PG&E Letter DCL-15-142

Response to NRC Letter dated November 5, 2015, "Request for Additional Information Related to the Environmental Review of the Diablo Canyon Power Plant, Units 1 and 2, License Renewal Application (CAC Nos. MF4019 and MF4020)"

Pacific Gas and Electric Company's Response to Nuclear Regulatory Commission's "Request for Additional Information Related to the Environmental Review of the Diablo Canyon Power Plant, Units 1 and 2, License Renewal Application," dated November 5, 2015

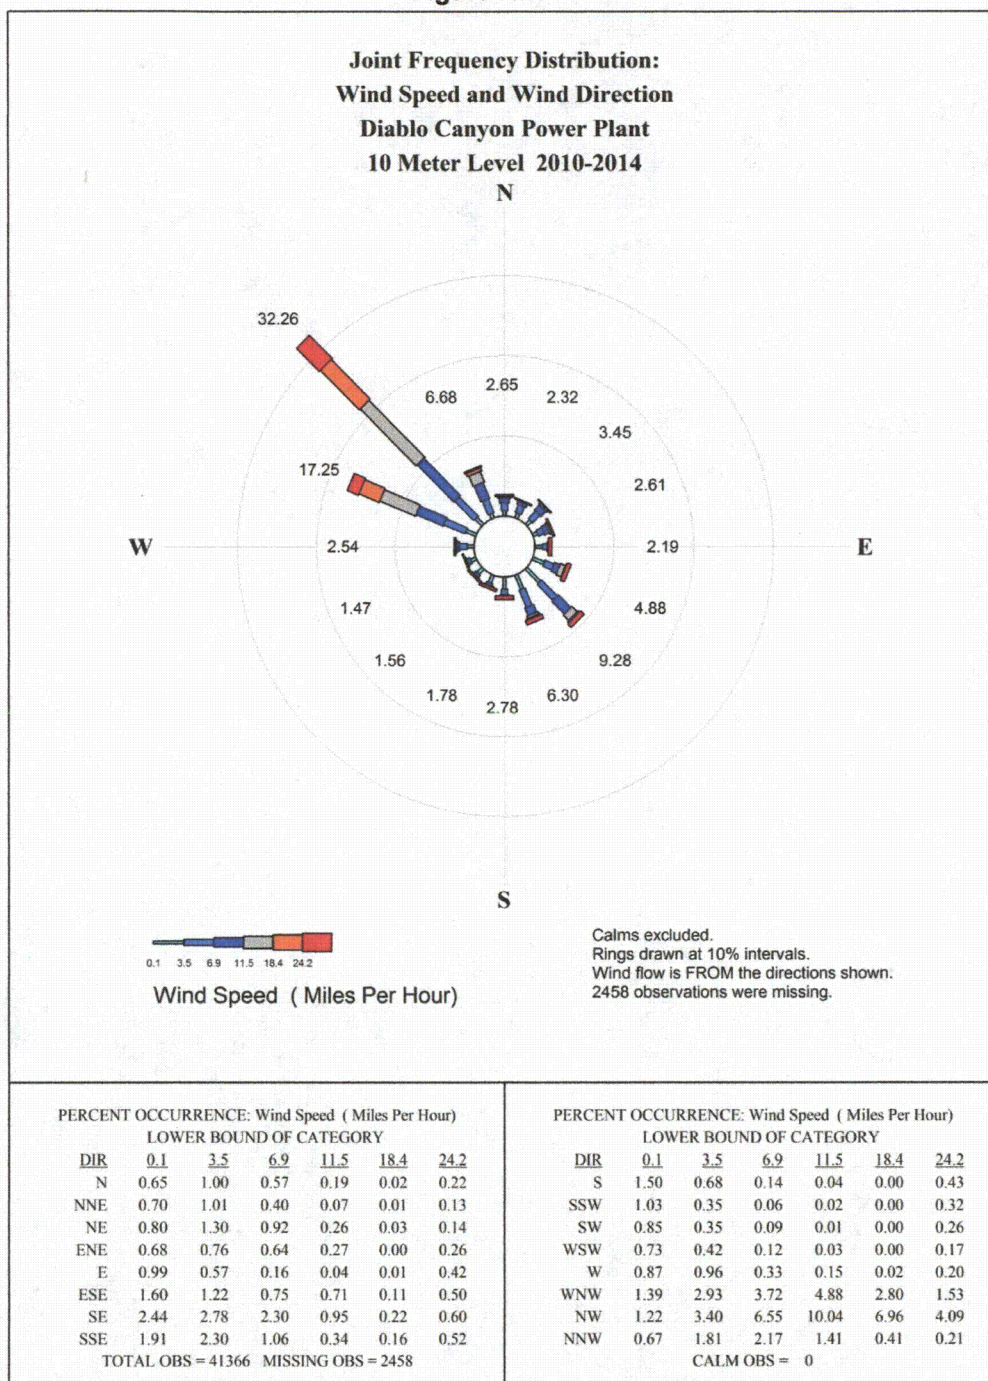
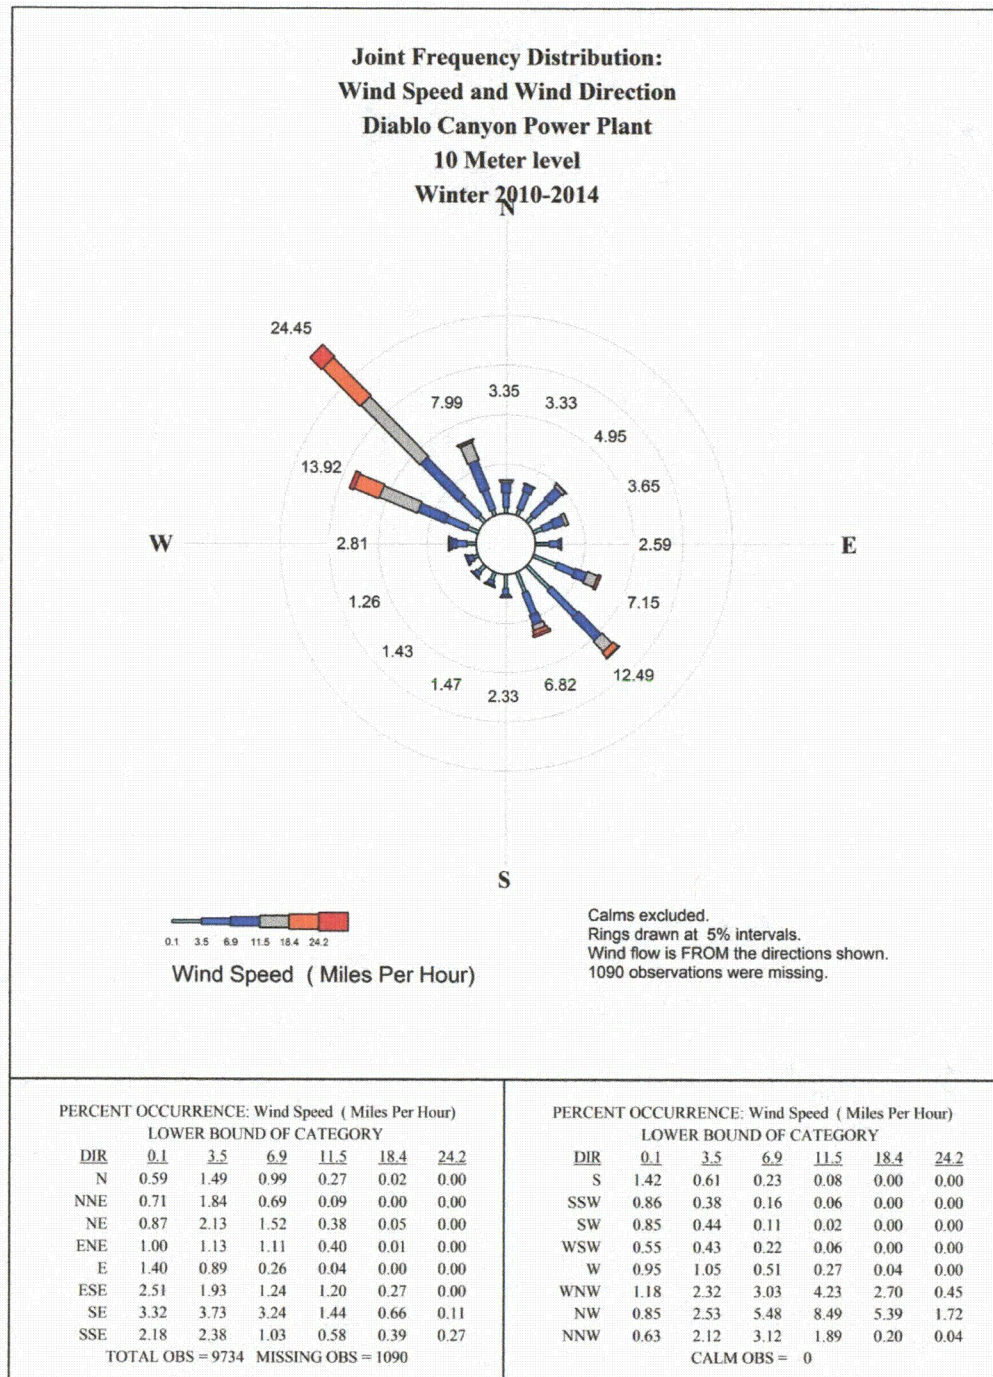
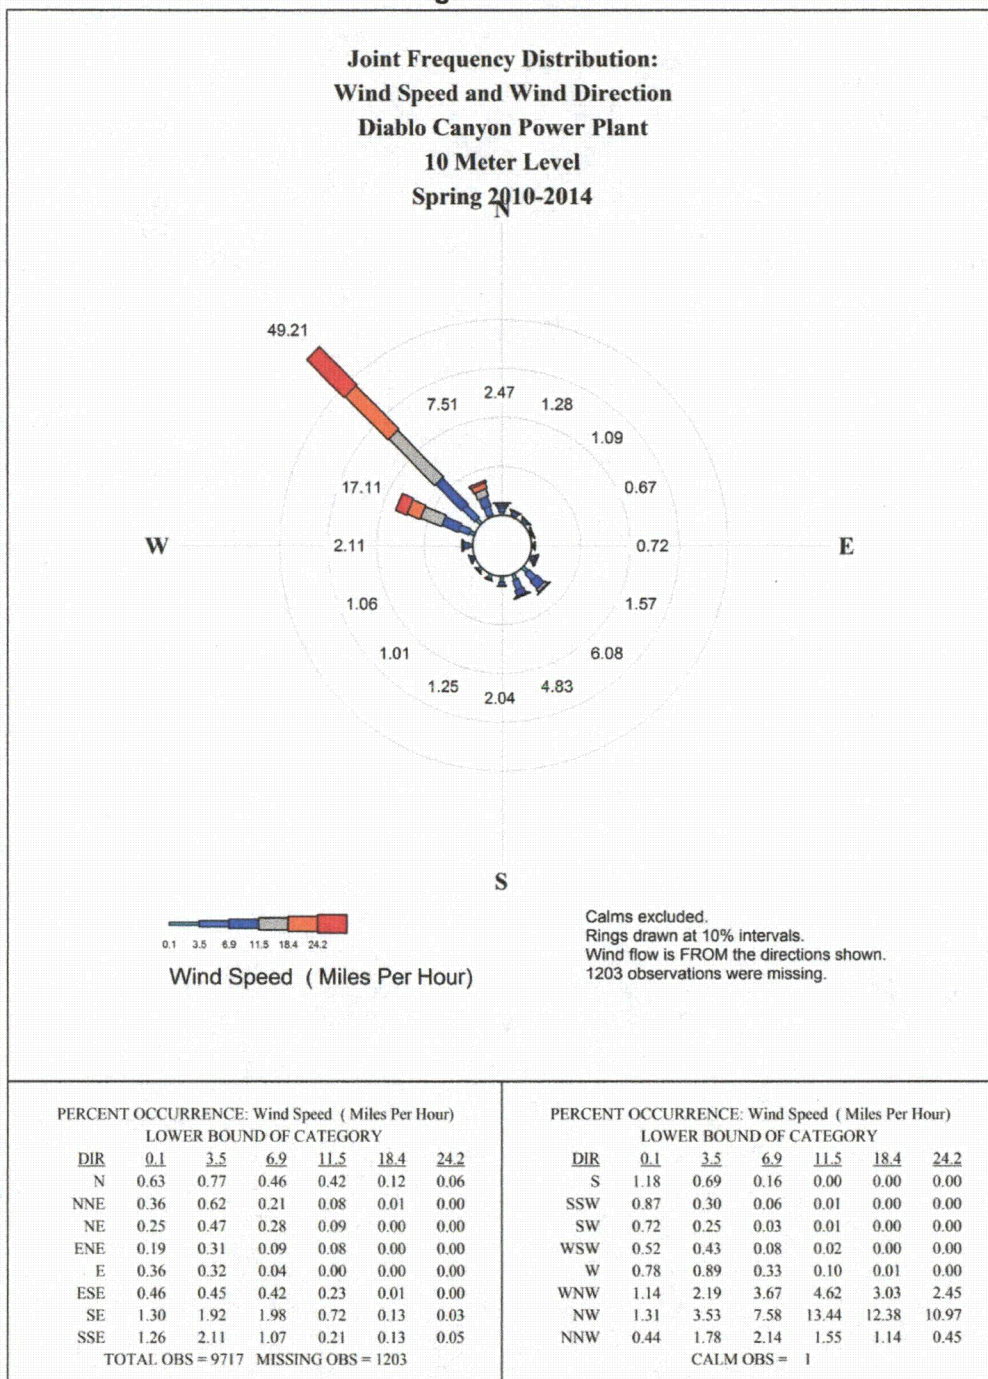
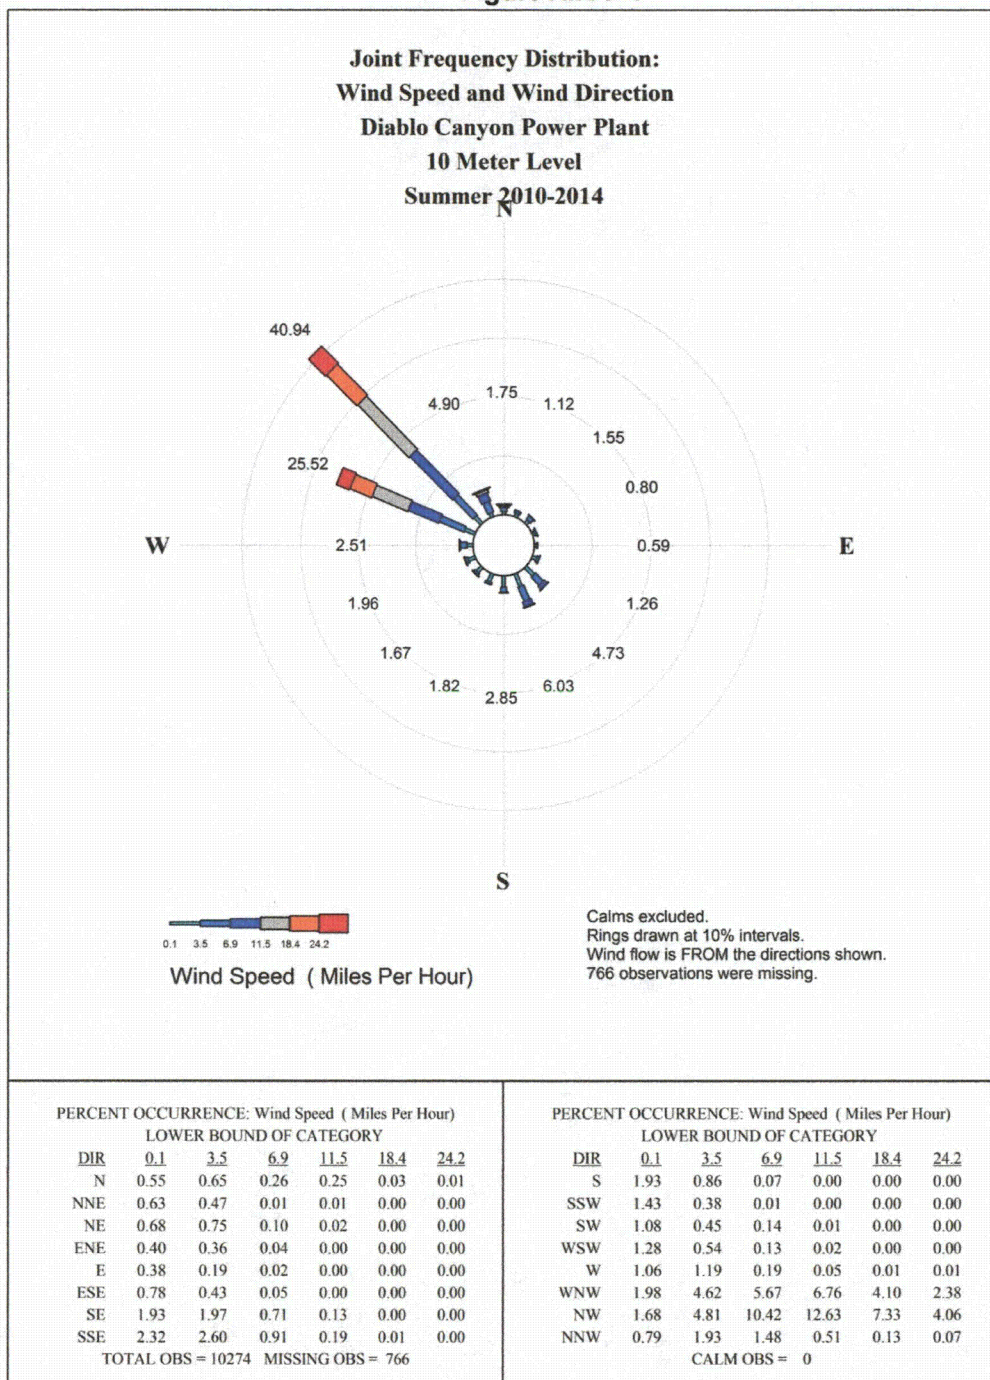
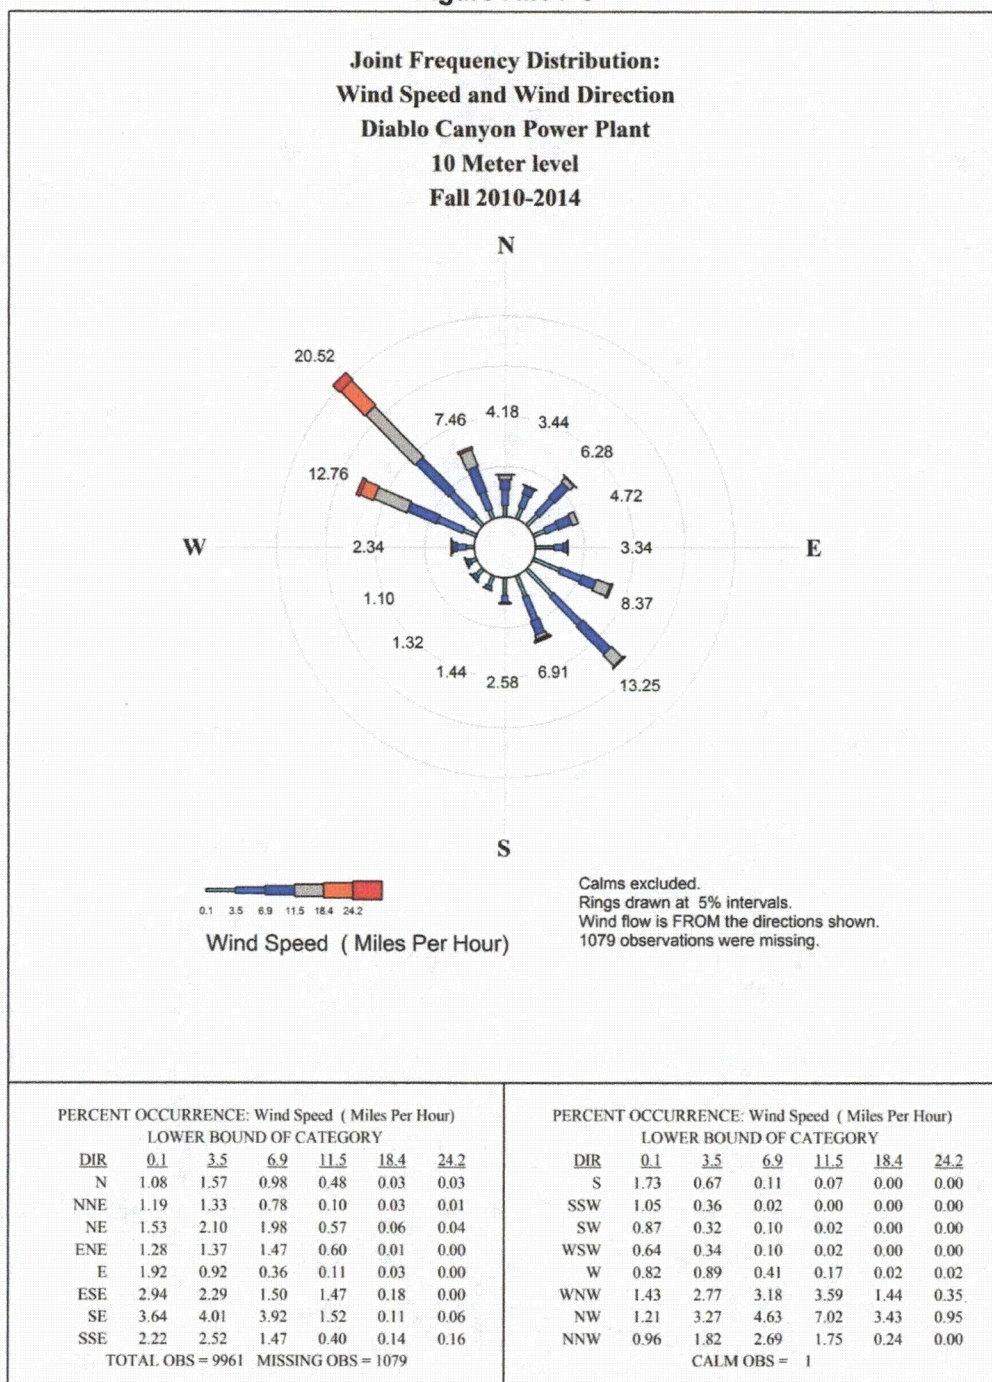
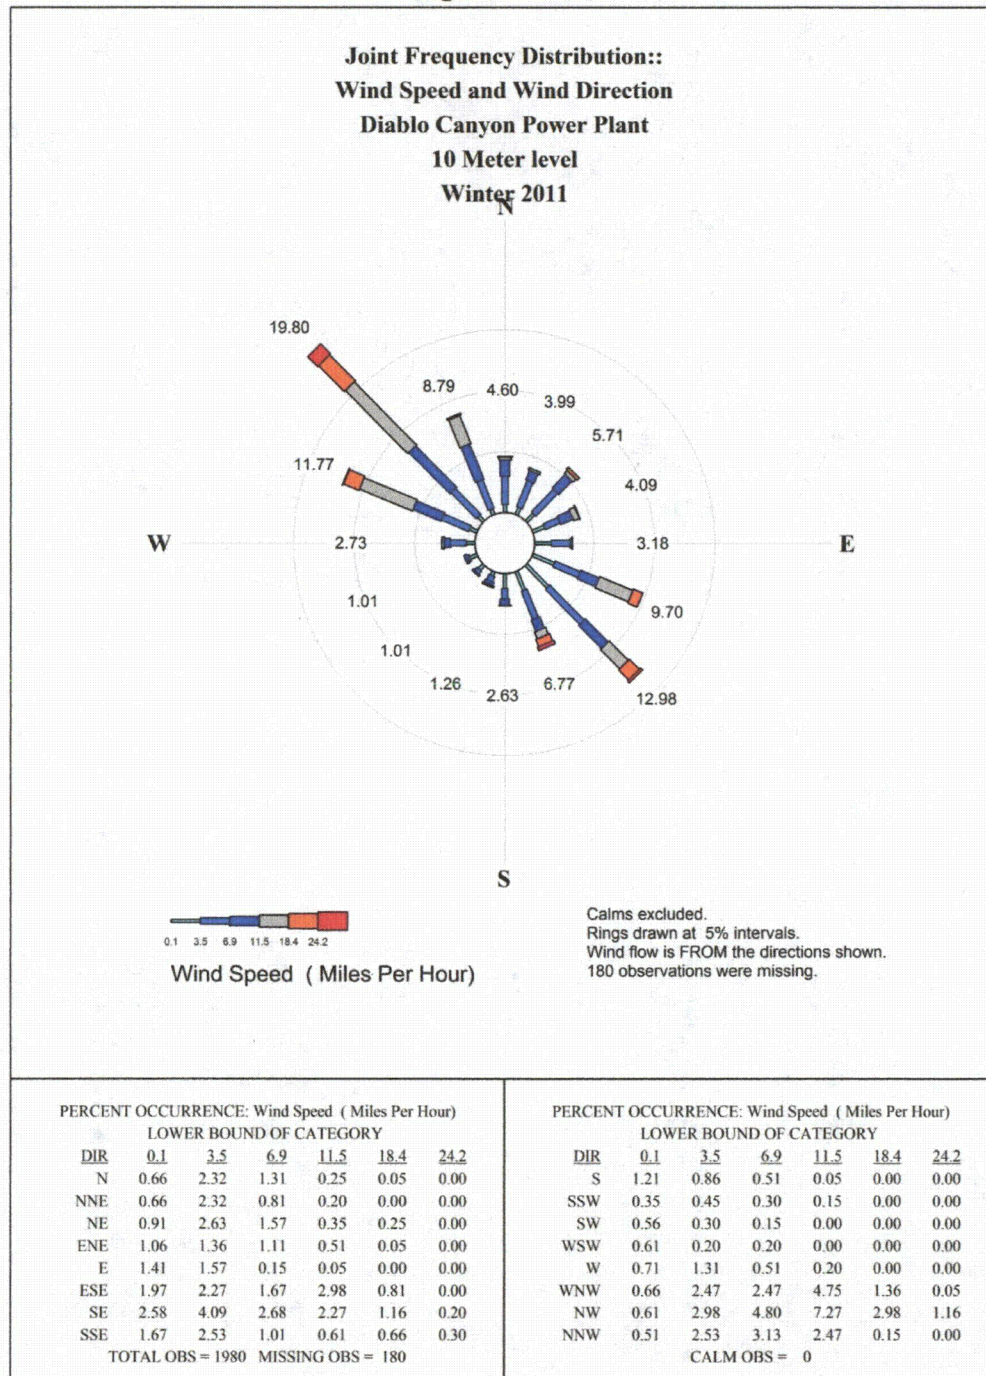
Provide seasonal and annual summary wind statistics in the form of wind direction and speed frequency distribution tables and wind roses from data recorded at DCP's meteorological facility. Discuss predominant wind direction and speed by season and annual average. The meteorological data should include the most recent 5 years for which the data are available.

The annual and seasonal wind direction frequency of occurrence for the DCP primary tower 10-m level for the period 2010 to 2014 are presented in Attachment 2, Tables AIR-7-1 through AIR-7-5. Annual and seasonal wind roses for DCP for the 2010 to 2014 periods are presented in Attachment 1 Figures AIR-7-1 through AIR-7-25. The wind rose presents the joint frequency of wind speed and wind direction recorded at the 10-m level at the plant. The wind direction is presented in 16 principal directions (north, north-northeast, northeast, north northwest) with each direction category encompassing a 22.5-degree sector centered on that direction. Six wind speed categories are used with the lower bounds at 0.1, 3.5, 6.9, 11.5, 18.4, and 24.2 miles per hour (mph). The length of each color band represents the frequency of a specific wind speed range. For example, northwesterly winds greater than 24.2 mph occurred 4.1 percent of the time for the period 2010 to 2014. Furthermore, below each wind rose diagram, is the same data displayed in table form for a more detailed breakdown of the seasonal wind direction and speed frequency distribution.
